Product Change Notification

Change Notification #: 113336-00
Change Title: Intel® Server System R1208BB4DC
PCN 113336-00, Product Design
Update the System Rear Panel
Date of Publication: October 22, 2014

Intel is implementing the following changes on the Intel® Server System R1208BB4DC:

Figure 1

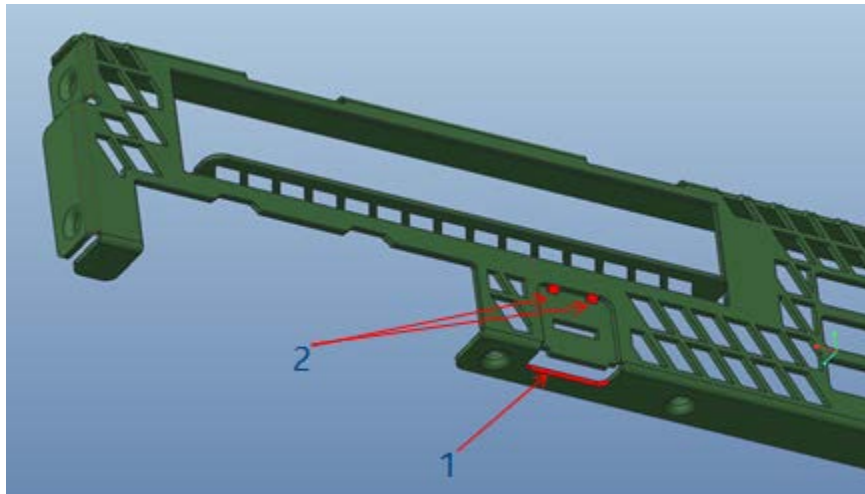
1. Add a connection at the bottom of the RMM4 (Remote Management Module 4) slot to improve structure strength. See item 1 in Figure 1.
2. Update the one big center joint to two smaller joints so that the joints will not conflict with the LAN cable connector latch. See item 2 in Figure 1.

Figure 3

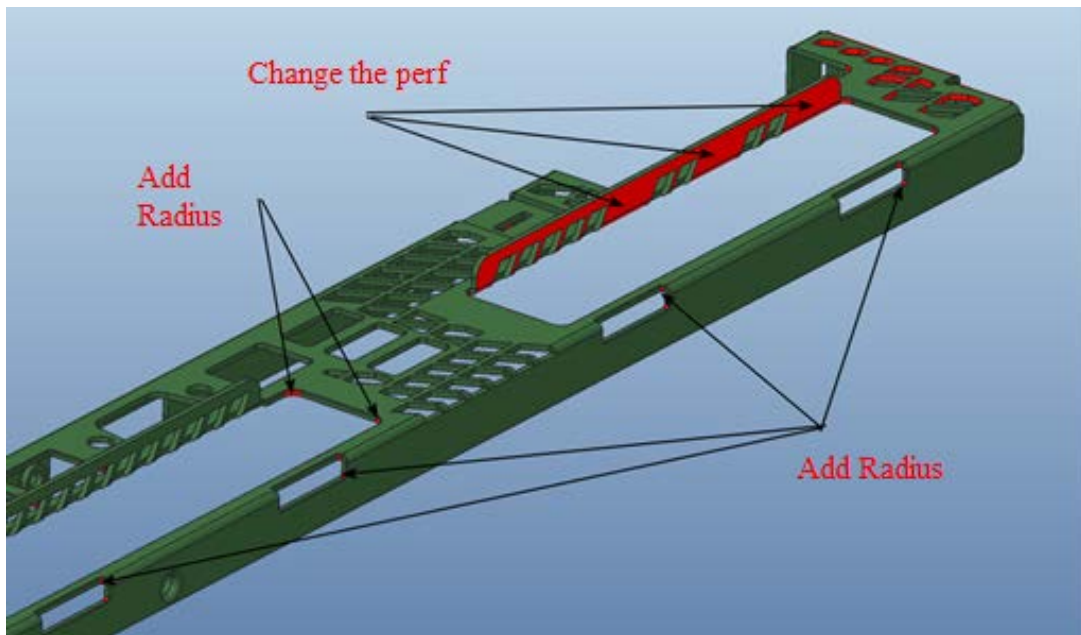
4. Update the perf and add radius to improve structure strength. See Figure 3 and 4.

Figure 5

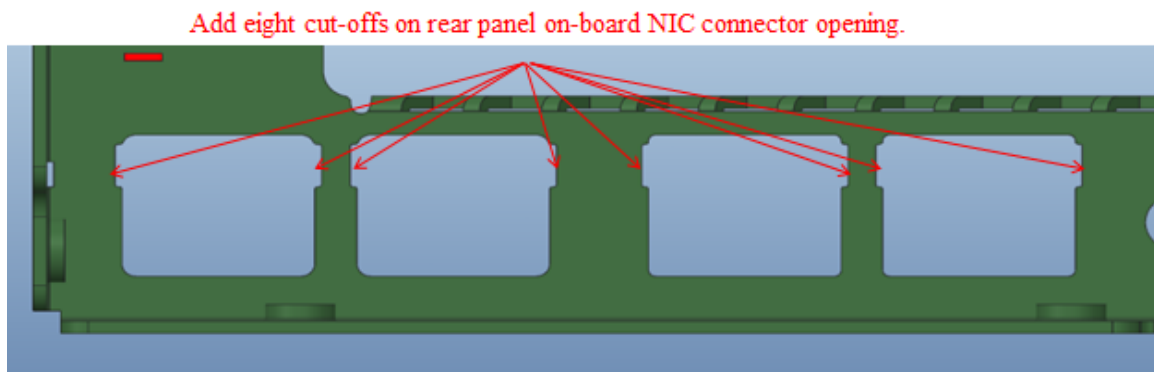
5. Add eight cut-offs around the on-board NIC (Network Interface Controller) openings to improve the LED visibility. See Figure 5.
